Access Compliance Report

Public Rights-of-Way

(Curb Ramps)

Intersection ID: 21819	Main Street: AUTUMN_BLAZE_DR	Cross Street: POPLAR_FOREST_DR	Location: SW
ADA ID: 4EE8BCDC550E	Ramp Type: PerpDiag	Initial Pass/Fail: Fail	Overall Compliance: No
Severity Score: 35			
Codes/Mitigation Info/Possible Solution		Field Measurements/Component Compliance

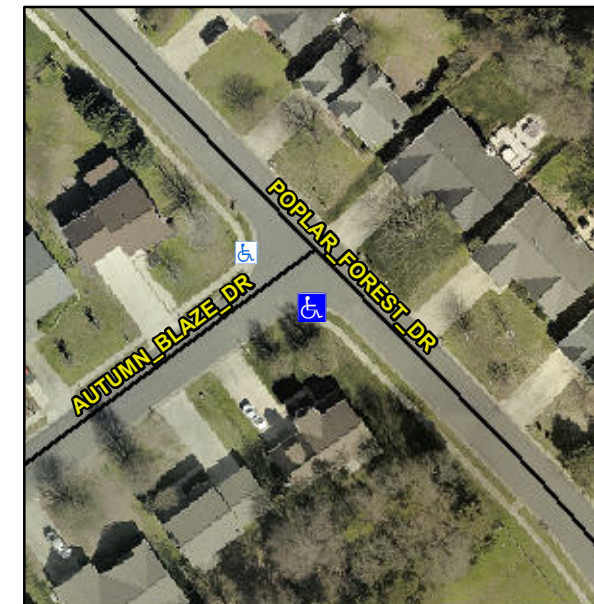
Compliance	Description	Data	Compliance	Description	Data
N/A	Ramp Length (in)	96.0	Yes	Ramp Slope (%)	6.1
No	Ramp Width (in)	30.5	Yes	Ramp XSlope (%)	0.5
N/A	Flare Type LT	N/A	N/A	Flare Type RT	N/A
N/A	Flare Slope LT (%)	N/A	N/A	Flare Slope RT (%)	N/A
N/A	Flare Traversable LT?	N/A	N/A	Flare Traversable RT?	N/A
N/A	Landing Length (in)	N/A	N/A	DWS Provided?	N/A
N/A	Landing Width (in)	N/A	N/A	DWS Contrast?	N/A
N/A	Landing Slope (%)	N/A	N/A	DWS Length (in)	N/A
N/A	Landing X Slope (%)	N/A	N/A	DWS Full Width?	N/A
N/A	Landing Curb? (Y/N)	N/A	N/A	DWS Offset (in)	N/A
N/A	Shared Landing?	N/A			
N/A	Gutter Ponding?	N/A	N/A	Gutter Slope (%)	N/A
N/A	Gutter Lip Ht (in)	1.5	N/A	Gutter X Slope (%)	N/A
N/A	Painted X Walk1?	No	N/A	Painted X Walk2?	No
	X Walk 1 Direction	To NE		X Walk 2 Direction	To NW
N/A	X Walk 1 Width (in)	N/A	N/A	X Walk 2 Width (in)	N/A
	X Walk 1 Slope (%)	1.5		X Walk 2 Slope (%)	3.3
	X Walk 1 X Slope (%)	0.7		X Walk 2 X Slope (%)	1.0

N/A	Ramp inside XWalk1?	N/A	N/A	Ramp inside XWalk2?	N/A
	Road Slope (%)	0.5	N/A	Clear Space?	N/A
	Road X Slope (%)	6.5	N/A	Clear Space to XWalk (in)	N/A
N/A	Any Obstructions?	N/A	N/A	Storm Grate/Utility Hazard?	N/A
	Obstruction Type			Storm Grate/Utility Type	
		N/A			N/A
		Yes		Surface Condition? (G/P)	Good

Remove & Replace Curb Ramp With Two New Directional Ramps or Equivalent.

R304.5.1
